HISTORIC AND DESIGN REVIEW COMMISSION

June 29, 2022

HDRC CASE NO: 2022-353
ADDRESS: 1722 S ST MARYS ST
LEGAL DESCRIPTION: NCB 2979 BLK LOT W 42.8 FT OF S 22 FT OF 10
ZONING: IDZ-3, HL
CITY COUNCIL DIST.: 1
LANDMARK NAME: Individual Landmark
APPLICANT: Peter DeWitt/Adapt
OWNER: SANDERS SCOTT S/413 QUEEN ANNE CT
TYPE OF WORK: Fenestration changes, balcony removal, awning installation
APPLICATION RECEIVED: June 8, 2022
60-DAY REVIEW: Not applicable due to City Council Emergency Orders
CASE MANAGER: Jessica Anderson

REQUEST:

DEMO EXT
ELEVATIONS

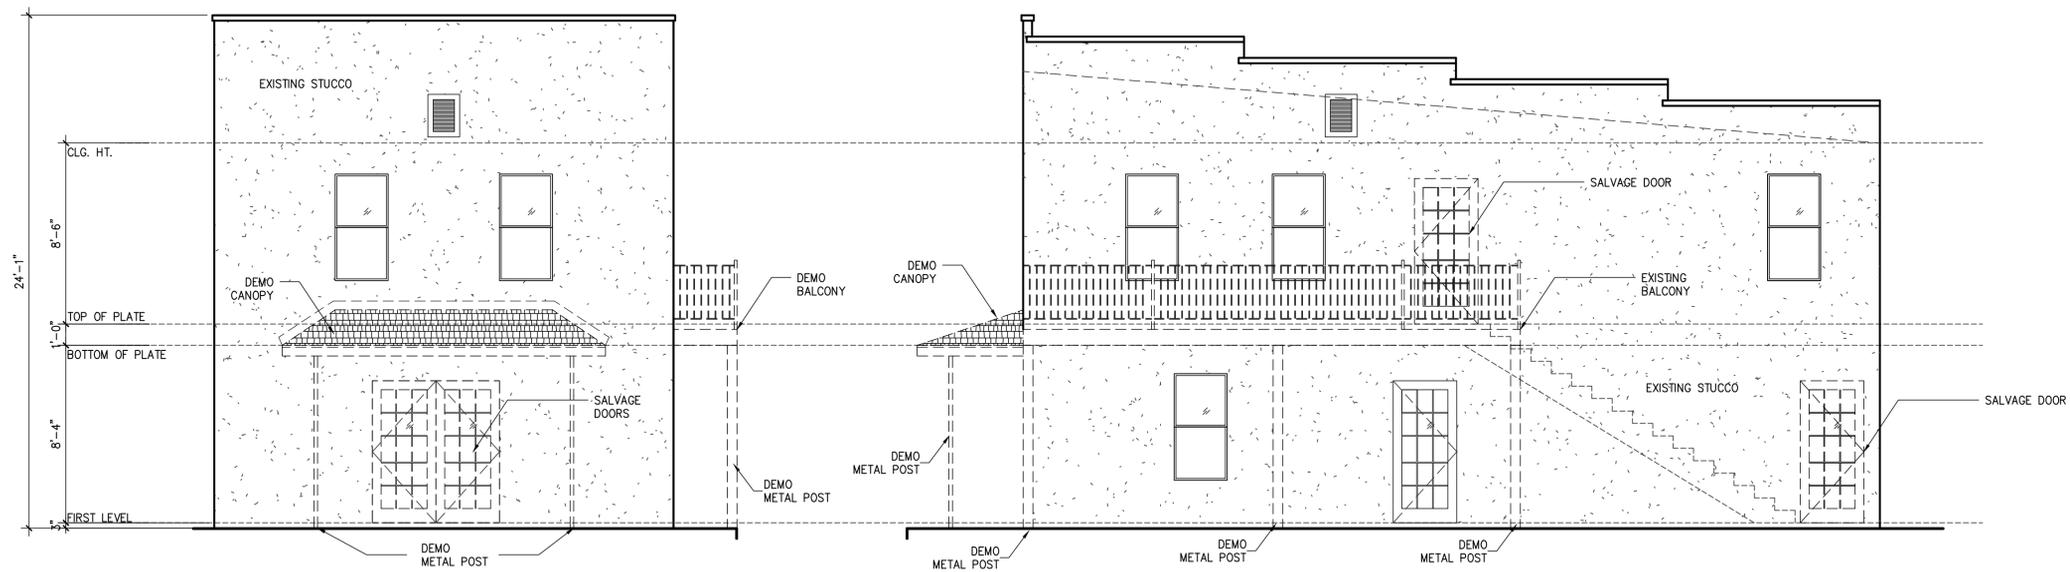
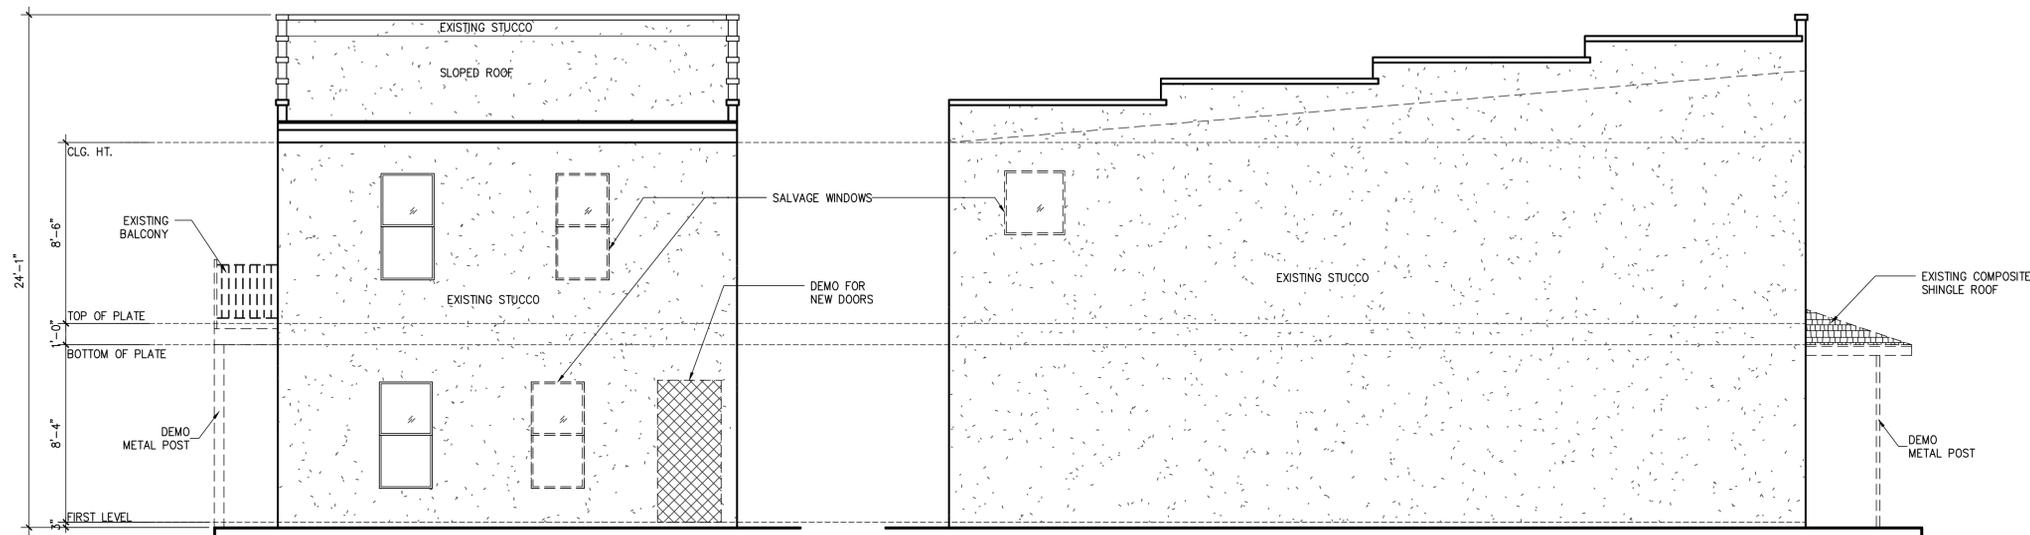
- c. **FENESTRATION CHANGES:** The applicant requests approval to infill two windows on the east elevation and one window on the north elevation, replace two doors on the south elevation with windows salvaged from the east elevation, and add one door to the east elevation salvaged from the south elevation. Per Historic Design Guidelines Chapter 2, 6.A.i, existing opening should be preserved. Staff finds these requests do not conform to guidelines.

- d. **WINDOWS:** The applicant requests approval to infill two windows on the east elevation and one on the north elevation and replace two doors on the south elevation with one-over-one windows. Per Historic Design

- e. **DOORS:** The applicant requests approval to replace two doors on the south elevation with windows and salvage one of the doors for a new door introduced on the first floor of the east elevation. Per Historic Design Guidelines Chapter 2, 6.A.i, existing openings should be preserved. Should the HDRC approve replacing existing south doors per finding c, staff finds salvage and reuse of a door on the east elevation appropriate. Should HDRC deny the request for fenestration changes, staff finds the addition of a new door on the east elevation generally appropriate since it appears at the rear of the structure. The new door should conform to Historic Design Guidelines Chapter 2, 6.B.i, which states that new doors should match existing doors in size, material, and profile. The new canopy should be based on architectural style of the building and be proportionate in shape and size to the scale of the building, per Historic Design Guidelines Chapter 2, 11.B.ii.

- f. **WEST CANOPY:** The applicant requests approval to remove and replace the existing west canopy and convert the existing south balcony to a canopy. Historic Design Guidelines Chapter 2, 10.A.i, suggests that character-defining features of historic buildings be preserved, and 10.A.iii suggests that missing features should be replaced in-kind based on evidence. The 1931 Sanborn Fire Insurance map, the first map on which the structure appears, shows a two-story store with one-story wraparound porch. Staff finds removal and replacement of the existing west canopy appropriate since it is not an historic feature.

- g. **SOUTH BALCONY:** The applicant requests to convert the existing south balcony to a canopy and remove the west end of the existing balcony. The 1931 Sanborn Fire Insurance map, the first map on which the structure appears, shows a two-story store with one-story wraparound porch. Staff finds removing part of the existing south porch and altering its function to a canopy does not conform to guidelines.

Staff does not recommend approval of item 1, infilling two windows on the east elevation and one window on the north elevation, based on finding c.

Staff does not recommend approval of item 2, replacing two doors on the south elevation with windows salvaged from the east elevation, based on findings d.

Staff recommends approval of item 3, adding one door with canopy to the east elevation, based on finding e, with the following stipulations:

- i. That the new door match existing doors in size, material, and profile.
- ii. That the new canopy be based on architectural style of the building and be proportionate in shape and size to the scale of the building.

Staff recommends approval of item 4, removal and replacement of west canopy, based on finding f, with the following stipulation:

- i. That the new canopy be based on architectural style of the building and be proportionate in shape and size to the scale of the building.

Staff does not recommend approval of item 5, conversion of the existing south balcony to a canopy, based on finding g.
